Company	Trenz Electronic GmbH
PCN Number	PCN-20240621a
Title	TE0821-01 to TE0821-02 Hardware Revision Change (Revised)
Subject	Hardware Revision Change
Issue Date	(2024-07-22), Revised 2024-10-08

This change affects all Trenz Electronic TE0821 SoMs: TE0821-01*.

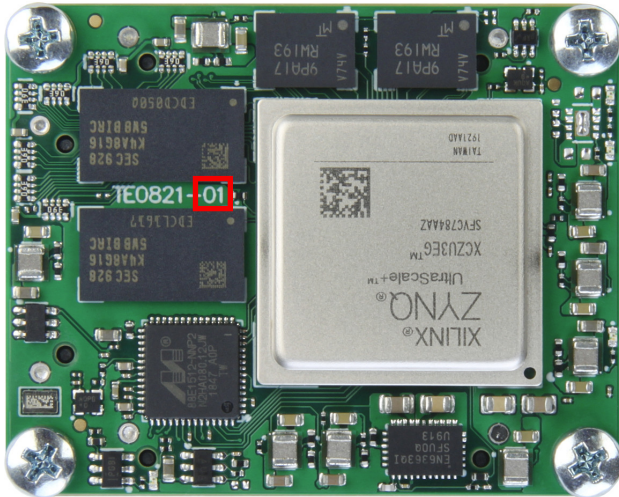
#32 Adapted power supply for clock (U11) and clock generator (U10) from 3.3 V to 1.8 V.

Type: Schematic change

Reason: Follow Ethernet PHY recommendation.

Impact: None.
